PROPOSED TECHNICAL SPECIFICATION REVISION

EXPLOSIVE GAS MIXTURE

LIMITING CONDITION FOR OPERATION (McGuire Unit I)

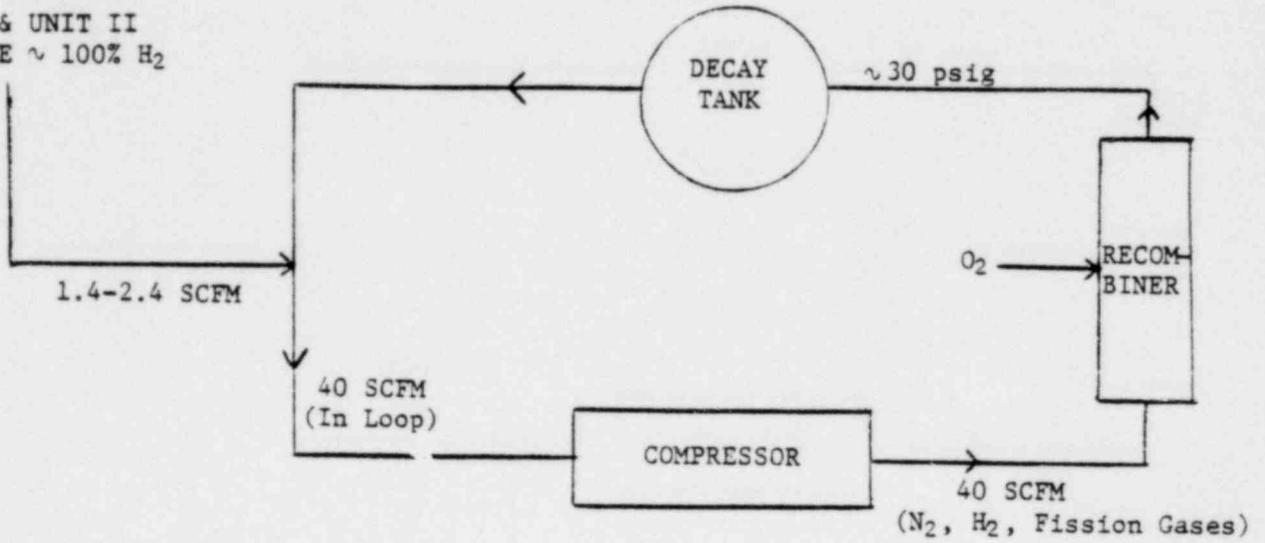
- 1) Below 5.0% Oxygen, no mixture of hydrogen and oxygen is flammable with nitrogen acting as the diluent in this mixture.<sup>1</sup> This is the case for the McGuire Waste Gas System.

MODE (B)

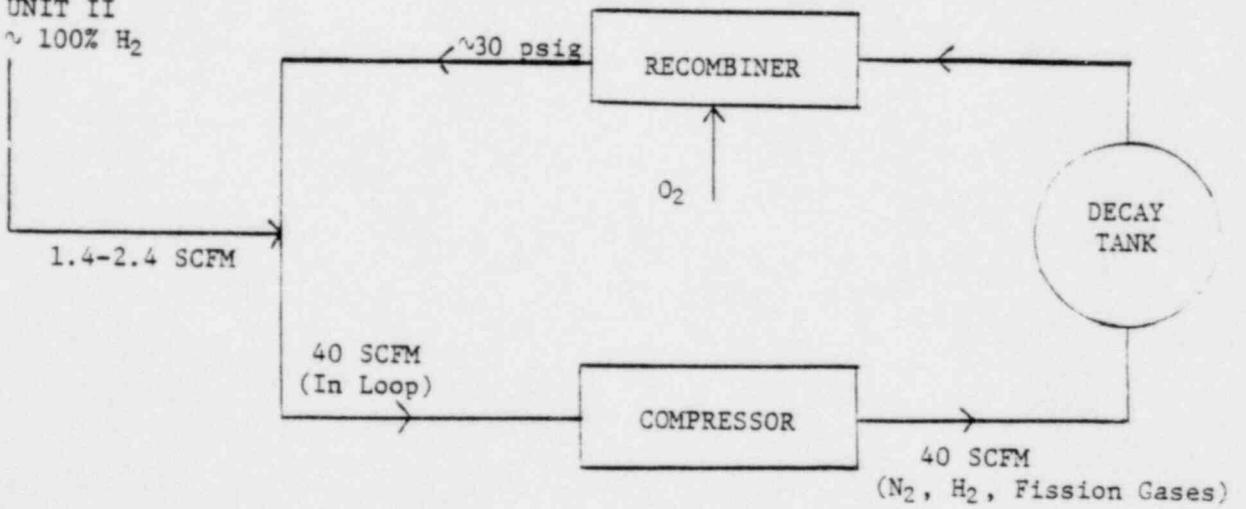
Mode B would normally be the means by which the tank in Mode A is used and filled to its allowable limit (approximately 100 psig -140 psig). However, as the Mode (B) diagram below shows, this would not be possible with the demands of the 3.11.2.6 Technical Specification.

Example: Flow from Units I and II = 1.4 SCFM (100% H<sub>2</sub>)

This would give a 3.5% H<sub>2</sub> concentration in the Waste Gas System loop, and eventually a 3.5% H<sub>2</sub> concentration in the WG Decay Tank in service. If the Decay Tank is at 25 psig (2.7 atmosphere), it would take approximately 40.5 minutes to reach this 3.5% H<sub>2</sub> concentration in the tank, based on the following estimate:

With 0 psig (1 atm) in decay tank it would take approximately 8.5 minutes to reach a 2% H<sub>2</sub> concentration which is the present Technical Specification limit.<sup>2</sup> At 100 psig in the tank, within 60 minutes this 2% concentration would be reached.

This points to either a flaw in the normal modes of operation of the WG System or, more likely, a discrepancy between the Technical Specification and reasonable limits for operating the system in Mode (B).

3.11.2.6 The concentration of oxygen in the waste gas holdup system shall be limited to  $\leq 3\%$  by volume.
